# Planning Response Report

Proposed Alterations to  
Approved Strategic Housing Development  
(Permitted under Ref. ABP-307092-20 & ABP-309899-21)  
Lands at Palmerstown Retail Park,  
Kennelsfort Road Lower, Palmerstown, Dublin 20

*Randelswood Holdings Ltd.*

**Fig. 5 – Permitted Site Layout Plan (ABP-309899-21)**

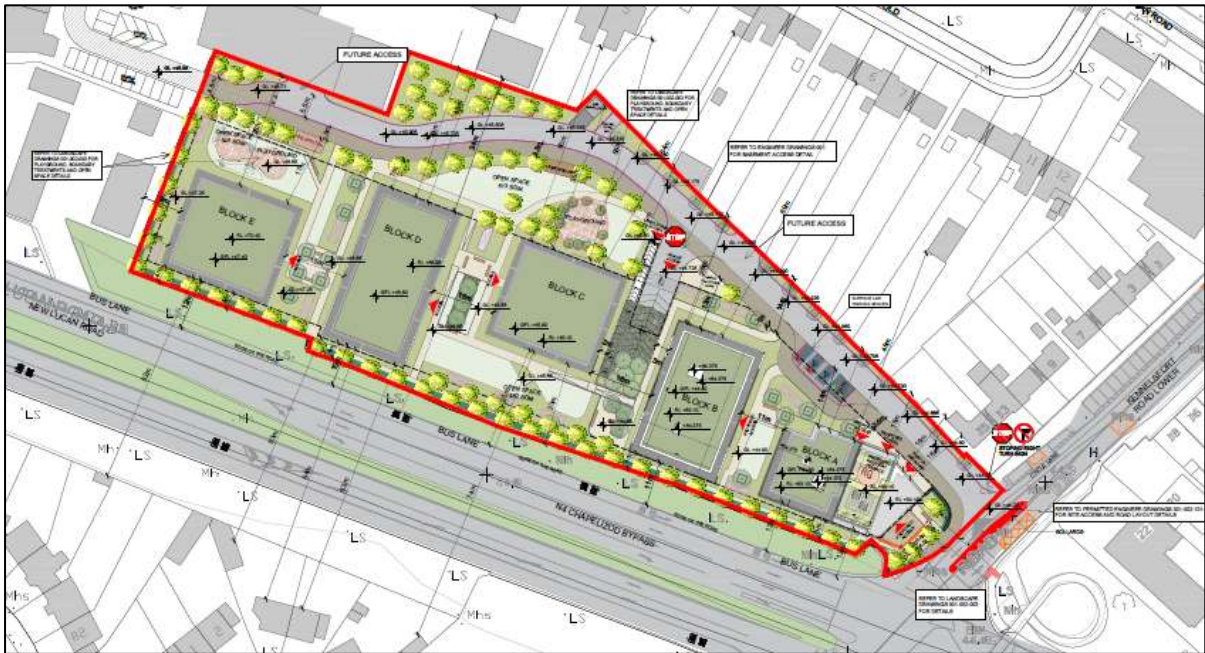
In term of open spaces, the landscape design incorporates minor alterations to accommodate the proposed minor increase in footprint/floor plans of Blocks C, D & E to accommodate construction method requirements and revised apartment mix/layouts. The landscape design creates a high-quality landscape for residents to partake with; an attractive landscape for people to live in and move through whilst enhancing the biodiversity value and ecological function of the green infrastructure network.
